SERVICE BULLETIN RELEASE - 05/05/2014

OIL SEEPAGE FROM JOINT SHAFT

Bulletin No: 03-001/14

Last Issued: 05/05/2014

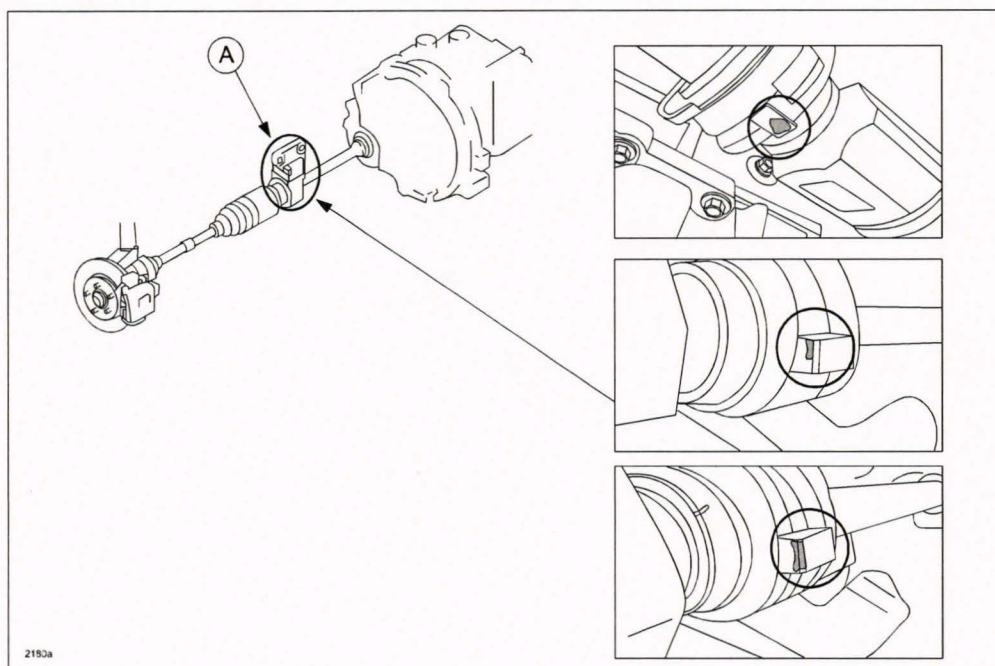
Some new vehicles may exhibit oil seepage underneath the bearing bracket (A) on the right side of the joint shaft. This is caused by the oil content separating from the grease applied to the bearing and spline seeping from the seal and bracket.

There is no functional problem with this issue since the amount of oil seepage is very small compared to the amount of grease. Note that the oil seepage will stop while the vehicle is in use.

If you encounter a customer complaint about this concern, wipe off the oil with a rag. DO NOT replace the joint shaft.
